Proj. No.: RA 140 DESIGN, BUILD, COMPLETE AND MAINTAIN SHEIKH JABER AL-AHMAD AL-SABAH CAUSEWAY PROJECT (MAIN LINK)	Employer: STATE OF KUWAIT MINISTRY OF PUBLIC WORKS	Request No. RA140-HDC-22-CBR- DRW-0025-03
Engineer's Representative:  dar al-handasah engineer and partners  SSH  TYLIN INTERNATIONAL	Contractor:  HYUNDAI ENGINEERING & CONSTRUCTION CO. LTD.	Date 13/02/2016

Transmittal of Design Drawing

Detailed Design - Main Bridge Pile Cap of Pylon Drawing Package

Comment & Response Sheet

DRAWING NO.
RA140-22-BRG-CW-DW-32295
REV.
B4

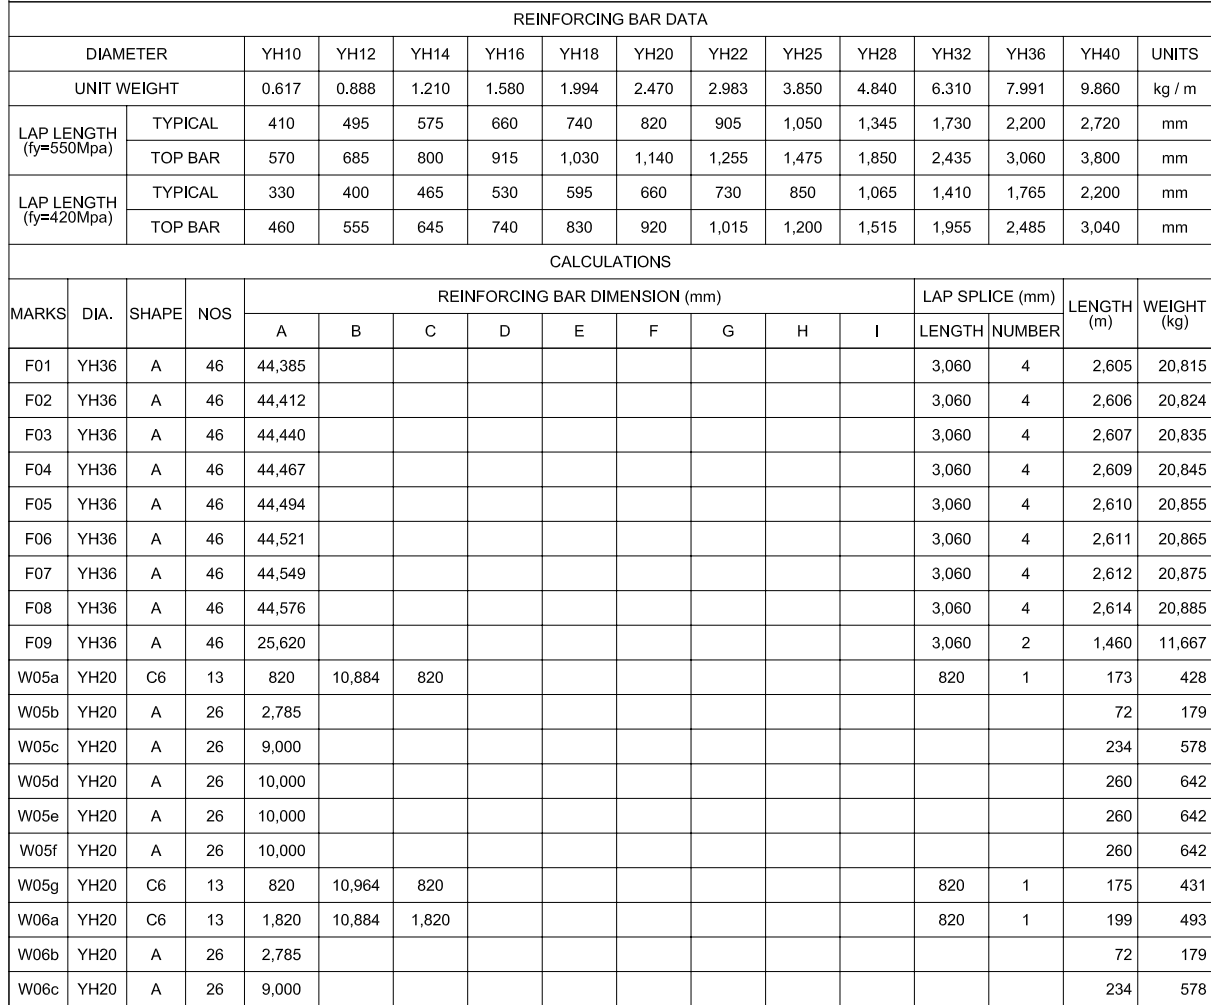
2 nd comment	Response is noted.	Noted.		BB
9	A3	32295	Bursting Reinforce ment Detail	1 st comment	Provide detailed conflict resolution study for the multiple mats of reinforcement and the PT bars in intersecting orientations.	<p>The PT bars have been rearranged, and the details reflecting conflict resolution have been provided in Section M-M.</p> 	2	
				2 nd comment	The conflict between the PT bars appear to be resolved but the new details have introduced numerous additional conflicts between the reinforcement in the anchorage zones. Please provide the resolution concept.	<p>Spirals for individual PT bars will be removed because a large base plate for the group PT bars will be used instead of individual base plate for each PT bar and bursting reinforcement provided can perform the role of the spirals.</p> <p>Rebar conflicts between PT bars and mat reinforcement can be resolved with small adjustment of reinforcement location.</p> <p>Please refer to the Attachment #2 which is BIM study for this area.</p>		CC

B2			3 rd comment	Noted. It is unclear how the PT bars and reinforcement are assembled without conflicts and enabling concrete to be placed without voids. Provide details and method statements.	<p>PT bars will be installed with PT bar frame to set them up at their exact position and then, reinforcement will be assembled to avoid PT bar and PT bar frame later. Shop drawing considering this condition will be submitted before construction.</p>		BB

B4			4 th comment	The plans should include the required corrosion protection. Please indicate which plan sheets include this information.			BB
16	B4	32295	Section N-N	1 st comment	Please provide dimensions for the proposed hole in the anchor plate.		1

DRAWING NO.
RA140-22-BRG-CW-DW-32299

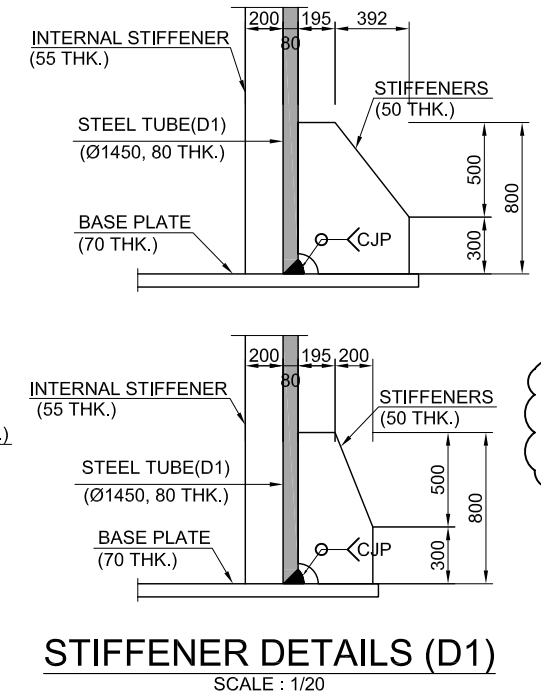
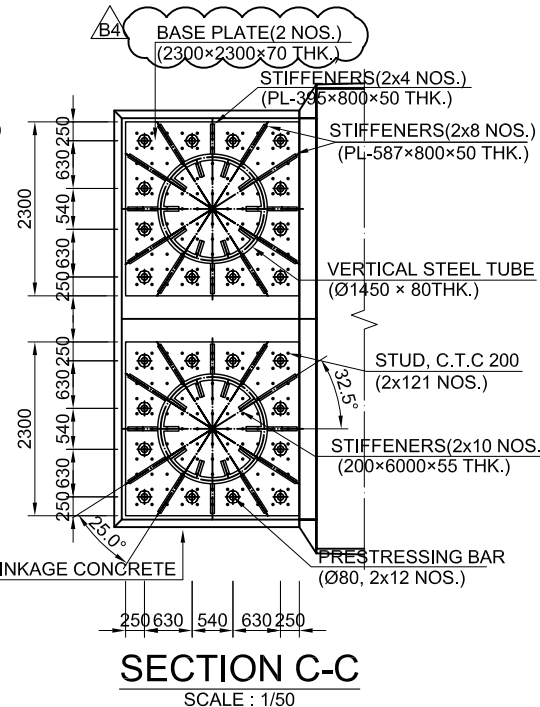
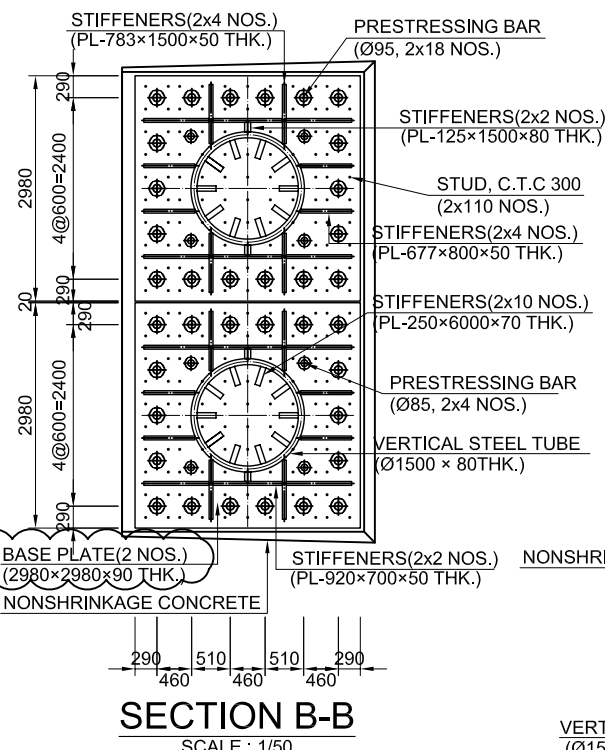
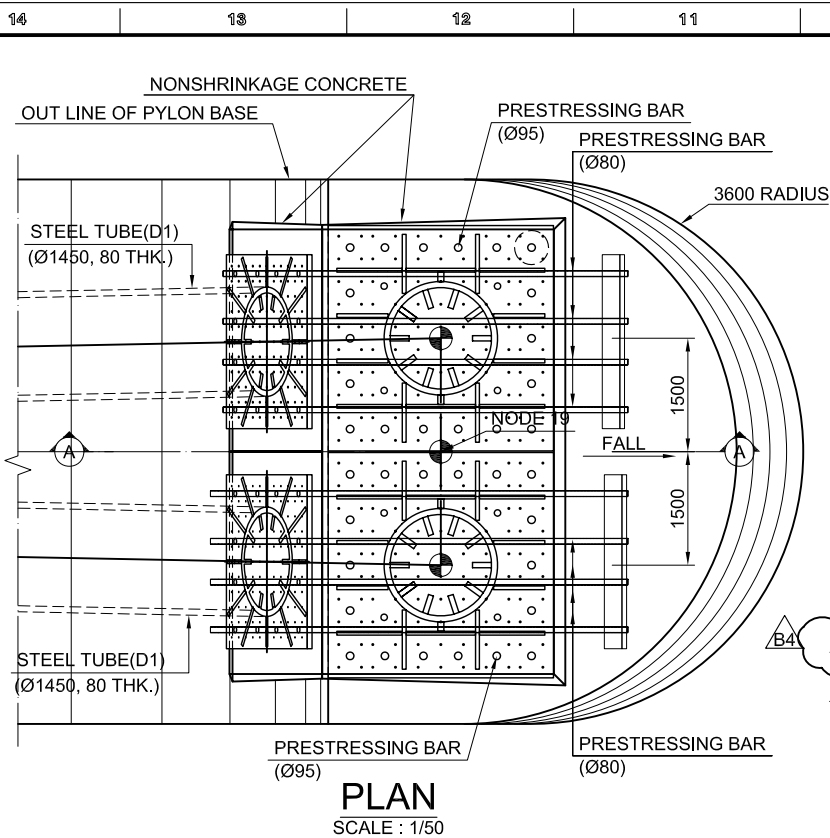
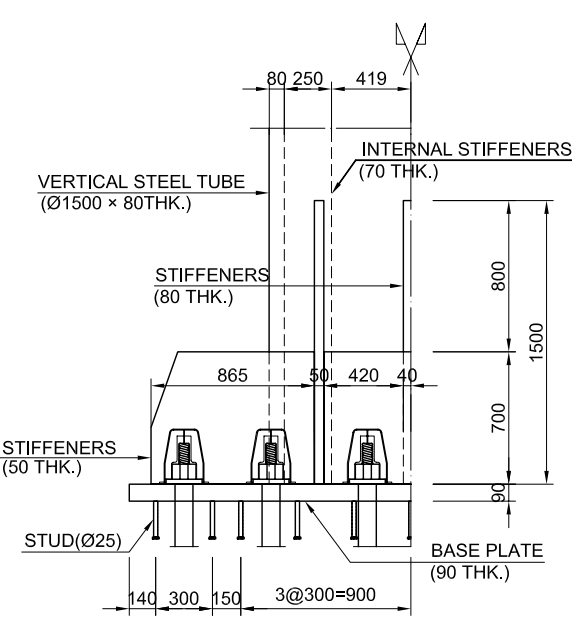
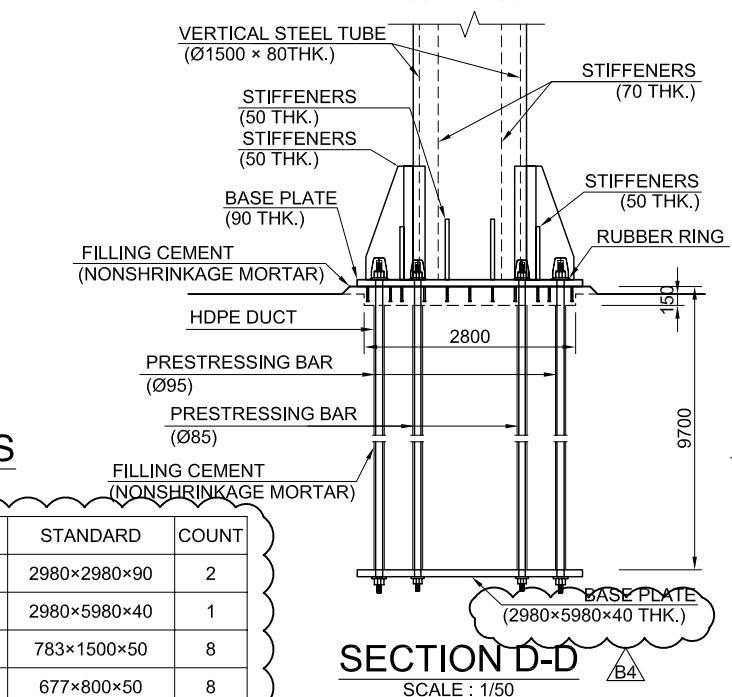
B4			4 th comment	Noted, shop drawings to be verified by site management.			BB
10	A3	32299	Plan	1 st comment	Multiple conflicts are shown in PT bars. Please provide detailed conflict resolution drawing including the mild reinforcement in the section showing that it is constructible.	Due to the conflict issue among PT bars, they have been rearranged in square as shown below. In addition, conflict resolution will be taken into account in a construction drawing so as to prevent interference between PT bars and reinforcement.	2

2 nd comment	The conflict between the PT bars appear to be resolved but the new details have introduced numerous additional conflicts between the reinforcement in the anchorage zones. Please provide the resolution concept.	Please refer to our answer to comment #9.		CC
	B2			3 rd comment	Refer to comment #9	Please refer to our answer to comment #9.		AA
11	A3	32299	Section D-D	1 st comment	Please explain the purpose of the rubber ring.	The rubber ring is placed at the nut cap for waterproofing of the PT bars.	1	
				2 nd comment	Please verify the rubber ring can carry the prestressing load. The ring appears to be placed between the nut and the	The rubber ring is only a rubber washer which is a component of nut cap. The rubber ring will not carry the prestressing		CC

bearing plate which requires all the PT load to be carried through the ring. Provide calculations for the system or a reference to the use of the detail in a code certified application by the supplier. The certifications in the attachments 5 and 6 do not appear to cover these items.	load of PT bar. Please be informed that the details shown on the drawing are indicative. The system details and construction method should be provided by a supplier, but he is not yet decided. Construction of PT bars is scheduled at January 2016 and the method statement including supplier's system details and construction method will be submitted to ER one month or earlier before commencement of construction.		
	B2			3 rd comment	Noted, however as shown rubber ring appears to be under the nut in the load path, please clarify. Submit system details and construction method when supplier is selected.	The rubber ring shown on the drawing is indicative only. Selected supplier is Freyssinet and they confirmed that rubber ring wouldn't be required. It will be reflected in the shop drawing.		BB

B4			4 th comment	Noted, shop drawings to be verified by site management.			BB
12	A3	32299	Section D-D	1 st comment	Clarify protection for durability of the exposed base plate and PT bars.	For such protection, grouting and nut cap are applied to the PT bars and painting is applied to the base plate.	2	
				2 nd comment	Response is noted. Please confirm that the general notes sheets that cover these drawings include the specific materials and coatings for these items or add specific notes to the sheet.	Please be informed that all materials used in the project should be approved by ER before its application. Notes for specific materials and coatings will be added in construction drawing as well as method statement after a system supplier is selected.		BB
	B2			3 rd comment	Provide materials and coatings data as well as method statement when system supplier is selected.	Selected supplier is Freyssinet. Please refer to the attached the technical sheet from Freyssinet. Method statement will be submitted soon.		BB

B4			4 th comment	The plans should define the corrosion protection requirements the supplier shall comply with. Please indicate the drawings where corrosion protection is defined in response to this comment.			BB

13	A3	32299	Section D-D	1 st comment	Provide details on how the PT bars are installed and stressed. Provide grout inlet tube and vent tube for the sleeves and system of drainage from the sleeve. Provide specification for filling cement mortar and sleeve.	The PT bars are pre-assembled with temporary fixing structures, inside of the sleeve for grouting. Detailed installation procedure will be included in the corresponding construction method statement. For the filling cement mortar and sleeve, the materials which ER approved for tendon will be used. Please refer to the Attachment #5 and #6.	2	
				2 nd comment	The specific installation of these items needs to be included on the drawings to ensure they are correctly placed in the field.	Noted.		BB
	B4			3 rd comment	Please update the drawings accordingly and note in response to this comment which drawings include the information requested.			BB

14	A3	32299	Section D-D	1 st comment	Please explain the purpose of the bar coupler	Since bar couplers are unnecessary for the PT Bar installation, they have been deleted from the drawing.	1	
				2 nd comment	Response is noted.			AA
15	A3	32299	Section A-A	1 st comment	How is the bar threaded in the bottom nut after concrete casting? Please clarify.	The PT bars are to be pre-assembled with temporary fixing structures, such as steel frames, to secure precise location of the PT bars during installation and construction. Accordingly, threading of the PT bars is to be done prior to the concrete casting at the factory or site yard. (Detailed installation procedure will be included in the corresponding construction method statement.) Thus, no threading issue into the bottom nut is foreseen.	1	
				2 nd comment	Please provide at least a draft version of the method statement which includes the details from comments 9 to 15. The response indicates the PT bars will be	Please refer to our answer to comment #11. For your reference, outline of work sequence of PT bar installation has been		CC

<p> tied into the rebar cage inside the ducts during placement of the rebar cage. Provide an estimated duration that the ungrouted bars will be on site inside the ducts where they cannot be inspected or cleaned of rust prior to concrete placement. A comprehensive durability strategy needs to be presented to address both the construction stages as well as service life. </p>	<p>presented in Attachment #3.</p> <p>Regarding durability issue, corrosion protection measure like lamellar zinc coating will be applied to PT bars. In addition, HDPE duct will be sealed with cap or tape as a picture below.</p>  <p> All details for corrosion protection also will be included in the method statement to be submitted later. But, you should note that galvanized PT bars have been used without additional protection in many other projects. </p>		
	B2			3 rd comment	Noted. Provide details and method statements.	<p>Please refer to our answer to comment #12. For corrosion protection, epoxy coating instead of galvanizing, cement grouting inside PP duct and sealing cap will be used. Method statement will be submitted soon.</p>		BB
